SAFETY RECALL

RZR

Communication #: Z-22-05

SUBJECT: PRIMARY CLUTCH FAILURE PURPOSE

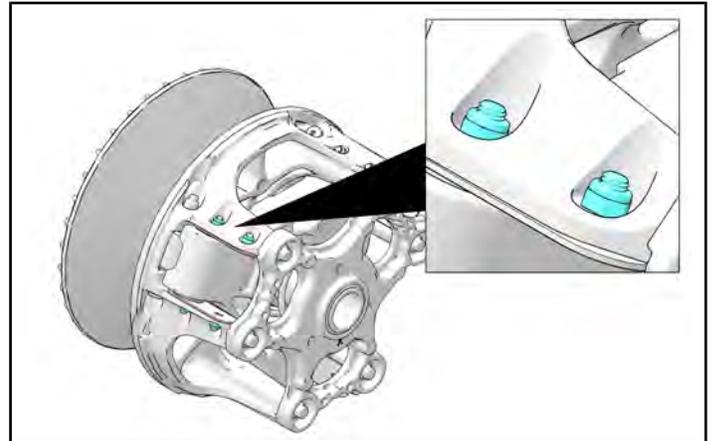
Service parts used in this bulletin look similar, but contain different primary clutch components. Ensure the correct clutch is installed.

Ensure that the correct clutch is installed. Installing the incorrect clutch can result in a vehicle hazard. Review the following images and table to ensure that the correct clutch is installed on the affected vehicle.

OLD CLUTCH

NEW CLUTCH

MODEL	NEW PART NUMBER (PN)
RZR TURBO S	1327410
RZR TURBO S 4	
RZR XP TURBO	
RZR XP 4 TURBO

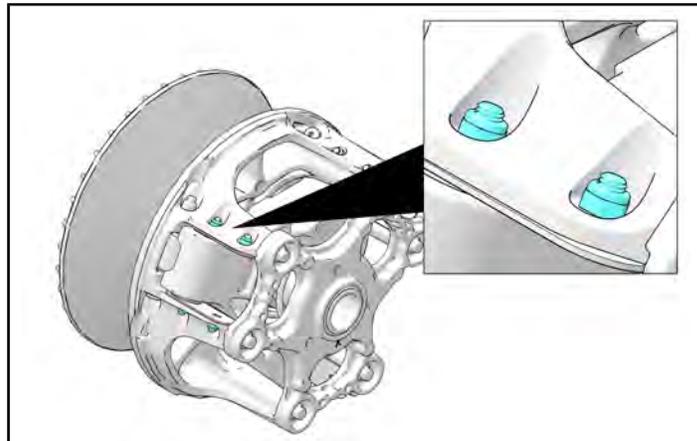
Service parts used in this bulletin look similar, but contain different primary clutch components. Ensure the correct clutch is installed.

Ensure that the correct clutch is installed. Installing the incorrect clutch can result in a vehicle hazard. Review the following images and table to ensure that the correct clutch is installed on the affected vehicle.

OLD CLUTCH

NEW CLUTCH

MODEL	NEW PART NUMBER (PN)
RZR TURBO S	1327410
RZR TURBO S 4	
RZR XP TURBO	
RZR XP 4 TURBO
